ADDENDUM # 01

Blue Ridge Community College

One Stop - Renovation Phase II

SCO ID# 18-18892-01A

1" = 30'-0"

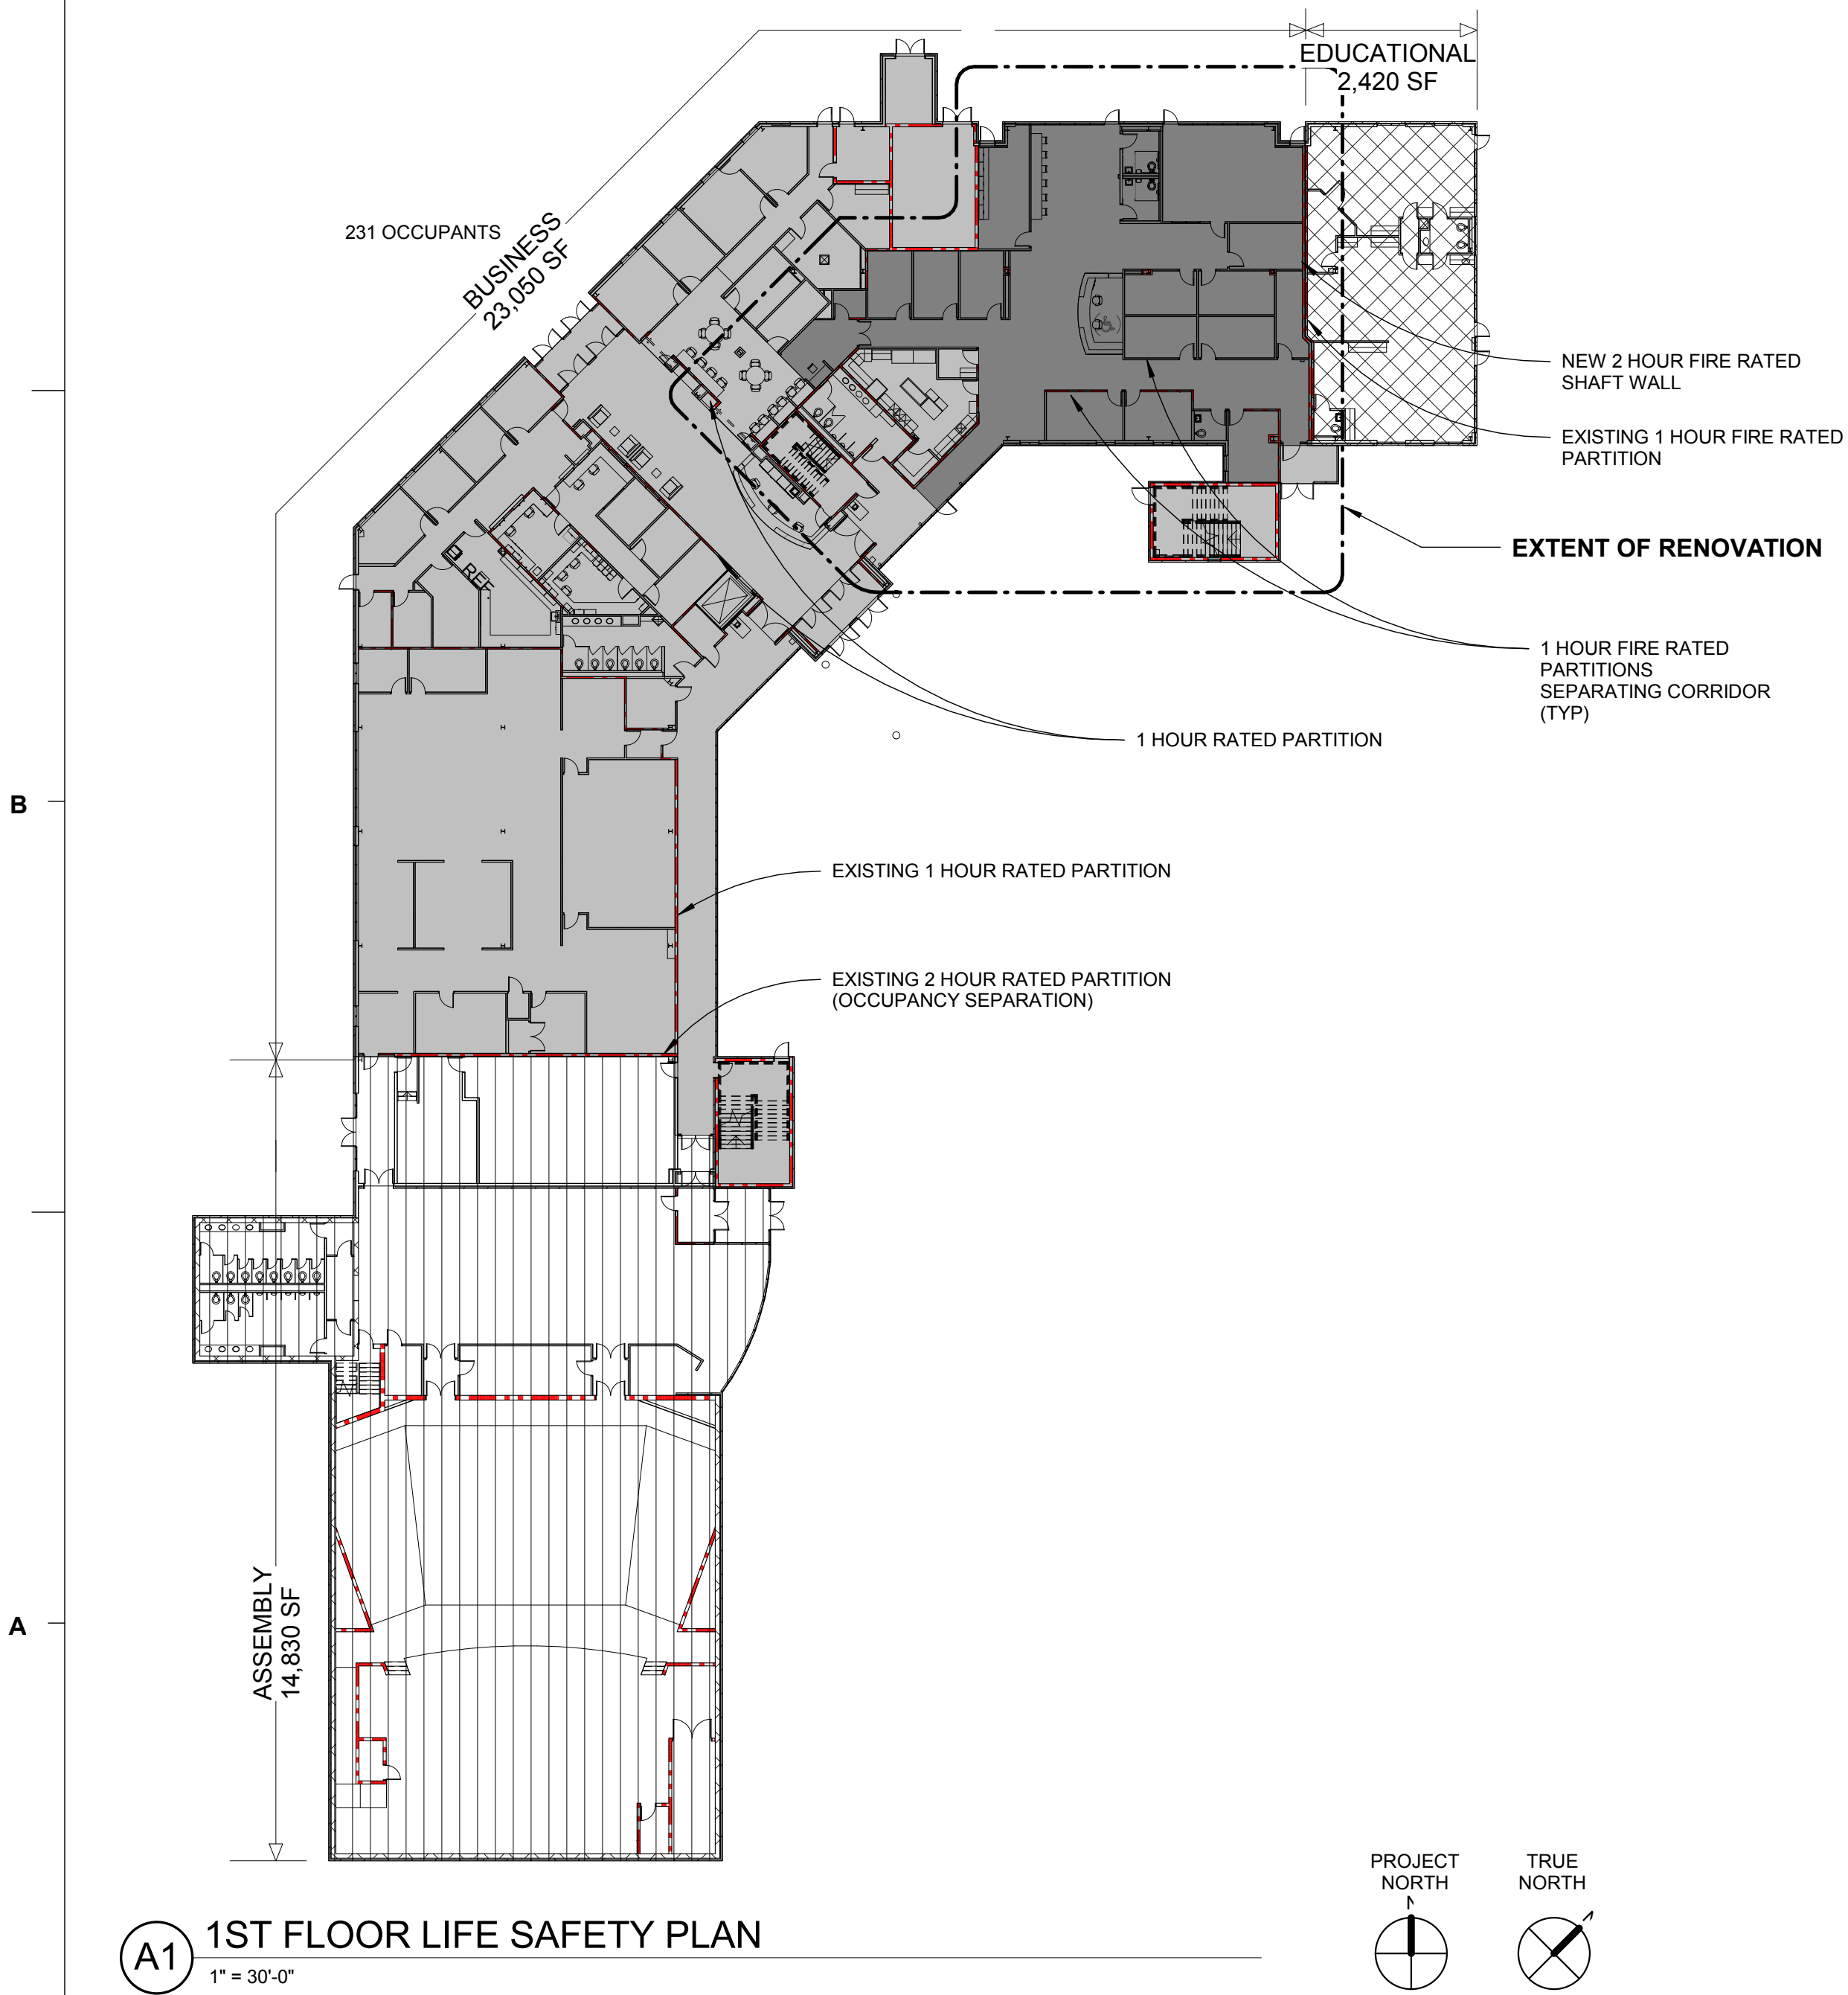
- 3.1 G-101 – LIFE SAFETY PLANS: Updated temporary barrier information.
- 3.2 A-002 – PARTITION TYPES: Updated partition type for walls at restrooms to extend to deck.
- 3.3 A-101 – FIRST FLOOR PLAN: Provided clarity for renovated components, wall types.
- 3.4 A-401 - ENLARGED PLANS: Updated restroom accessories information
- 3.5 A-601 – DOOR SCHEDULE, DOOR TYPE LEGEND & FRAME TYPES: Updated door information.
